RE: Region of Halton Additional Technical Comments
“Hidden Quarry” – James Dick Construction Ltd.
Proposed Class ‘A’ Category 2 License – Aggregate Operation
Township of Guelph/Eramosa Zoning By-law Amendment Application ZBA 09/12
West Half Lot 1, Concession 6, former geographic area of the Township of Eramosa

**Re: Hidden Quarry
Burnside Letter of October 6, 2014
Burnside Project No.: 300032475.0000**

Hidden Quarry Proposed Aggregate Extraction
Response to Burnside Letter of October 6, 2014

Figure 1: Water Levels in Multi-Level M15

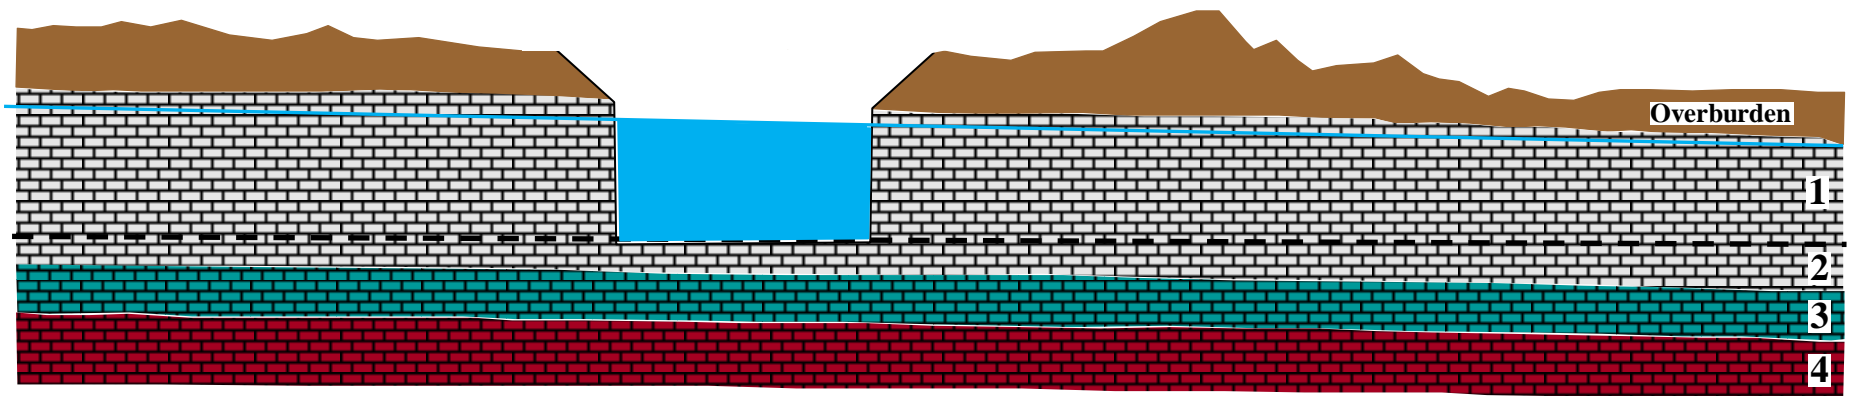
Figure 1 is a summary of the water levels obtained since May 2014. The relationship between the three deeper intervals (M15-I, II and III) remain the same throughout the summer and into the fall. The hydraulic relationship between the shallowest interval (M15-IV) and the deeper intervals changes from one of downward gradients in the spring to upward gradients in the fall. This change in relationship shows that the hydraulic seal installed effectively isolates M15-IV from the lower intervals and that on a local scale, M15-IV behaves somewhat differently than the lower intervals, although the general trend in water levels is the same. Interval M15-II has a consistently lower hydraulic head than interval M15-III above and M15-I below resulting in both upward and downward hydraulic gradients within the Gasport Aquifer. This

The water levels shown on Figure 1 confirm that the relationship changes seasonally and confirms that there is hydraulic separation between these intervals and that the integrity of the bentonite seals is intact.
